DEPARTMENT OF TRANSPORTATION

49 CFR Part 572

Anthropomorphic Test Devices; ES–2re Side Impact Crash Test Dummy 50th Percentile Adult Male

ACTION: Final rule, response to petitions for reconsideration, technical amendment.

FIGURE 1: FULL BODY THORAX IMPACT TEST RESULTS FOR UPPER RIB DEFLECTION

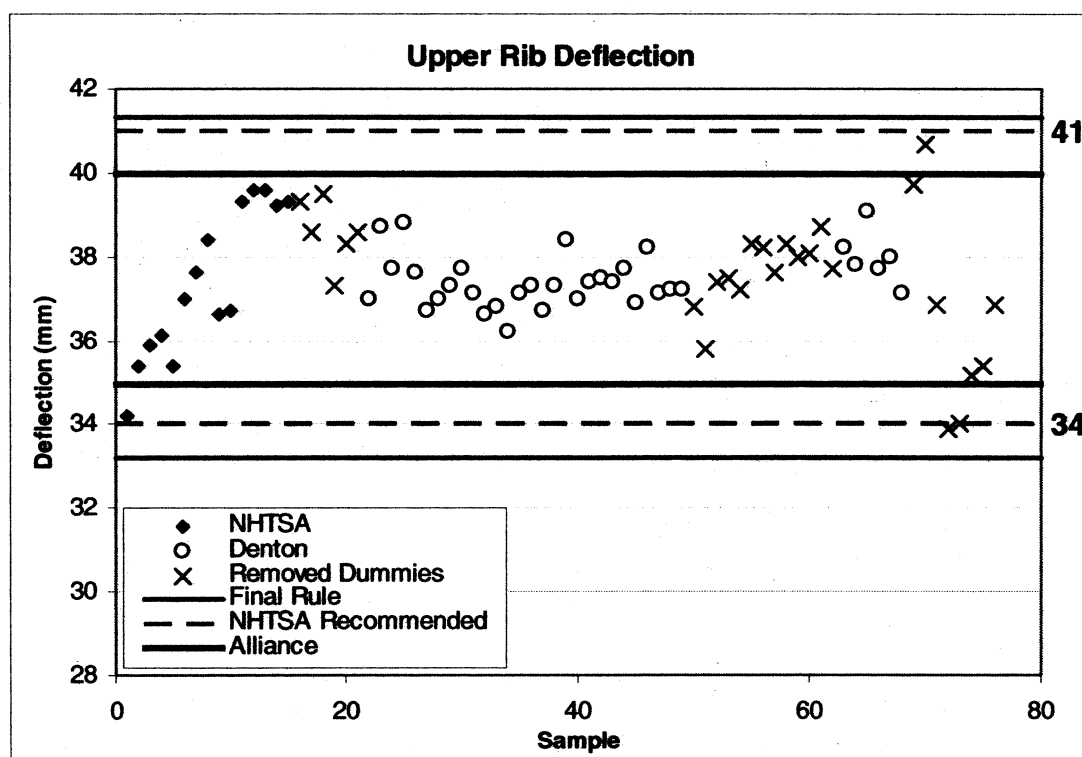
All of the data in the complete dataset (i.e., without any dummies removed) fit within the specified final rule corridor of 33.2–41.3 mm, as seen in Figure 1 below. The Alliance petitioned to narrow the corridor bounds to a range of 35–40 mm. The data set with the

indicated dummy responses removed (“revised data set”) has a mean deflection of 37.4 mm, a standard deviation of 1.11 mm and a CV of 2.96 percent. In that this CV is less than 3 percent, we could adopt corridor bounds that are expanded ± 3 standard deviations from the mean,¹⁴ or a range

of 34.1–40.8 mm. When rounded to the next whole numbers away from the mean, this corridor becomes 34–41 mm, which is only slightly narrowed compared to the final rule. This corridor contains nearly all the NHTSA and DTESC data points, and is well-centered about the mean.

FIGURE 2: MIDDLE RIB DEFLECTION RESULTS FROM FULL-BODY THORAX IMPACT TESTS

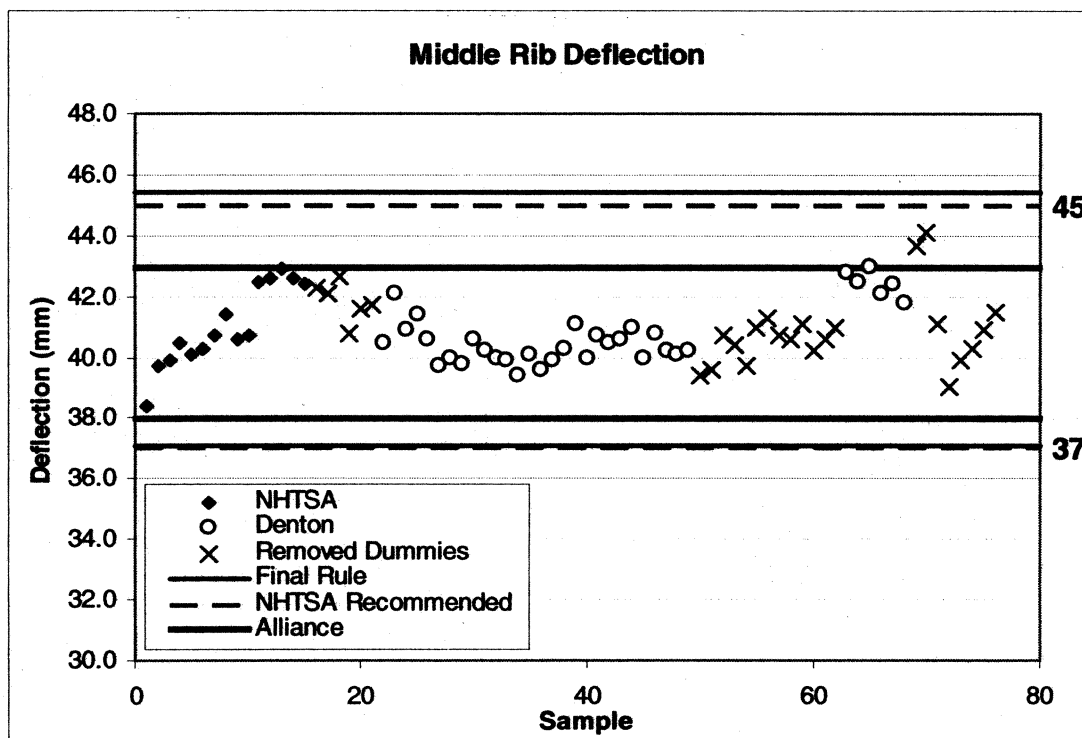
All data in the complete DTESC data set also fit within the corridors specified in the final rule for middle rib deflection, 37.1–45.4 mm (see Figure 2 below). However, the Alliance petitioned for narrowed corridor bounds

of 38–43 mm. Statistical analysis of the revised data set resulted in a mean response of 40.8 mm, a standard deviation of 1.09 mm and a CV of 2.67 percent. This CV allows for corridor bounds placed at ± 3 standard deviations from the mean, or a range of 37.6–44.1 mm (37–45 mm when rounded away

FIGURE 3: LOWER RIB DEFLECTION RESULTS FROM FULL BODY THORAX IMPACTS

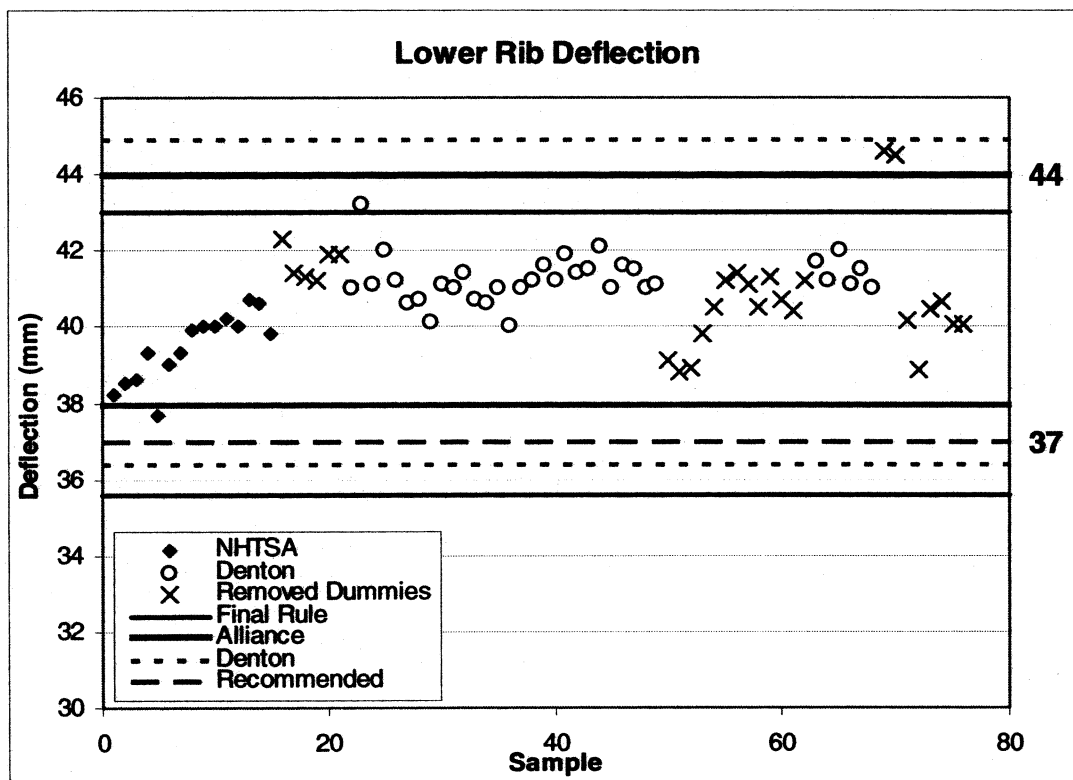
Denton and GM dummies in the DTESC-compiled data set submitted in Denton's petition for reconsideration show deflections that are generally higher than those measured by NHTSA. The final rule specified a range of 35.6–43.0 mm, while the Alliance and Denton recommended corridors ranging from 38–44 mm and 36.4–44.9 mm,

respectively. Based on statistical analysis of the revised DTESC data set, an adjustment of the corridor bounds to reflect these higher responses from a larger population of dummies is appropriate. The revised data set has a mean response of 40.7 mm, a standard deviation of 1.08 mm, and a CV of 2.66 percent. This CV allows for expansion of the bounds ± 3 standard deviations

from the mean, producing a range of 37.5–43.9 mm, or 37–44 mm when rounded away from the mean. This corridor is slightly smaller than and shifted upward from the final rule corridor, but wider than the corridor for which the Alliance petitioned. This corridor contains nearly all petitioner-submitted data as well as all NHTSA data (Figure 3).

FIGURE 4: TEST RESULTS FOR THE “PEAK IMPACTOR FORCE AFTER 6 MS” MEASUREMENT AS COLLECTED BY NHTSA, DENTON, GM AND FTSS

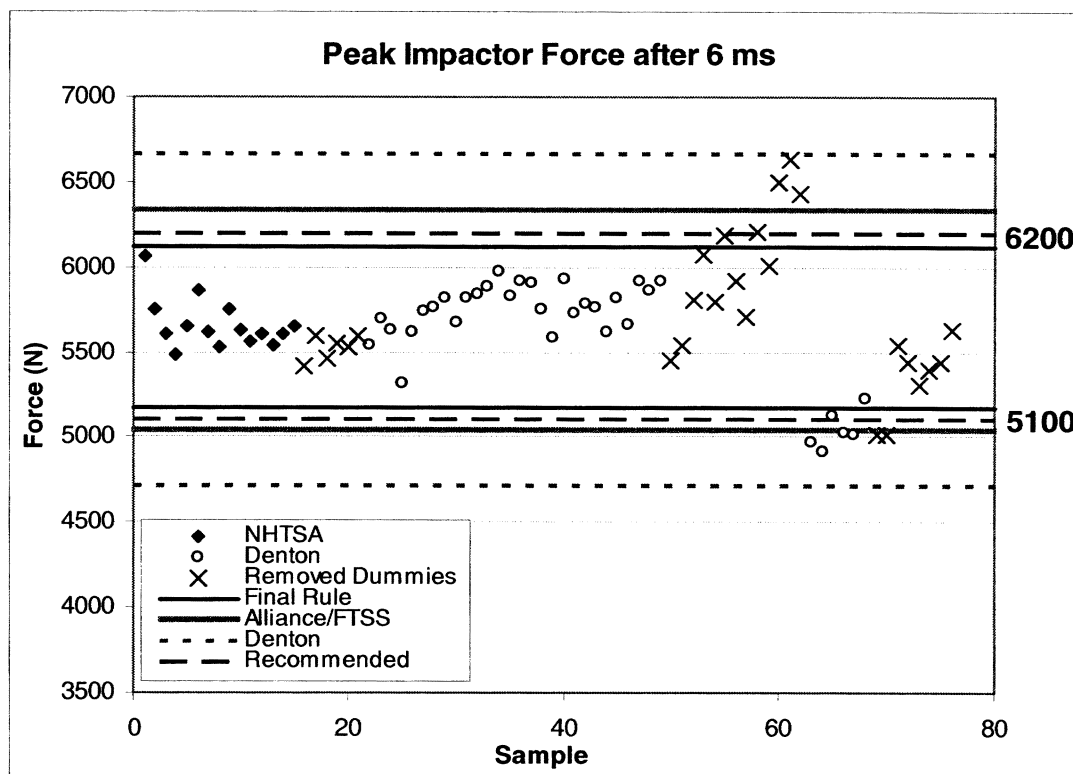
The additional peak impactor force data compiled by the SAE DTESC and submitted by Denton provide additional points with which to form statistically-based corridors. In its petition, the Alliance used this data set to propose a corridor of 5045–6344 N, while Denton recommended a range of 4720–6669 N,

as shown in Figure 4. FTSS recommended a performance corridor of 5039–6159 N for this measure. (The FTSS corridor is close to the Alliance recommendation, therefore to avoid clutter in Figure 4, it is shown to correspond to the Alliance corridor.) The mean response derived from the revised data set was 5643 N, with a SD

of 268 N and a CV of 4.76 percent. This CV allows for setting the corridor limits at ± 2 standard deviations from the mean, at 5107–6180 N. Rounded away from the mean, the lower and upper corridor bounds of the recommended corridor are 5100 N and 6200 N, respectively, a range very close to that which was petitioned by FTSS.

Figure U2-A
NECK/LUMBAR SPINE/HEADFORM ATTACHED TO PENDULUM

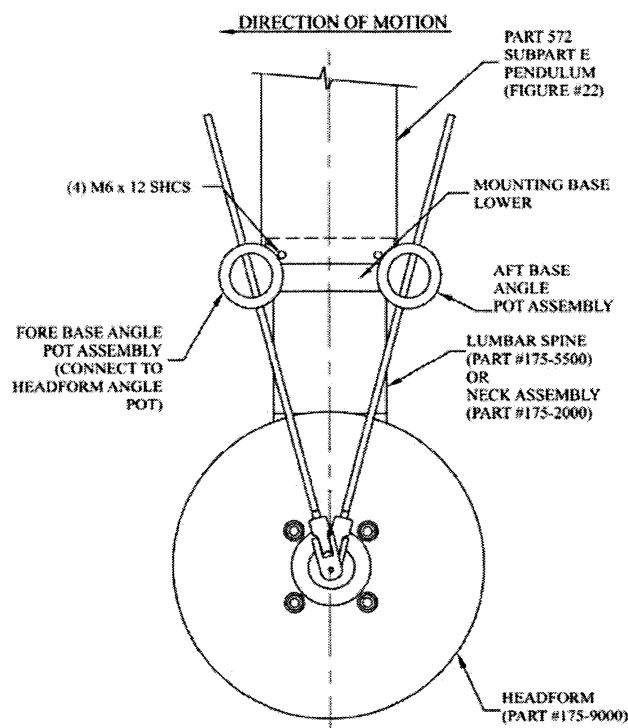
11. The agency has found an error in Figure U2-A, which specifies the pendulum for neck/lumbar spine qualification tests to be the "Part 572 Subpart E Pendulum (Figure #15)". The description and figure number do not refer to the same pendulum. This document makes a technical amendment by correcting the reference to read, "Part 572 Subpart E Pendulum (Figure #22)".

■ 8. Figure U2-A in “APPENDIX A TO SUBPART U OF PART 572—FIGURES” is revised to read as follows:
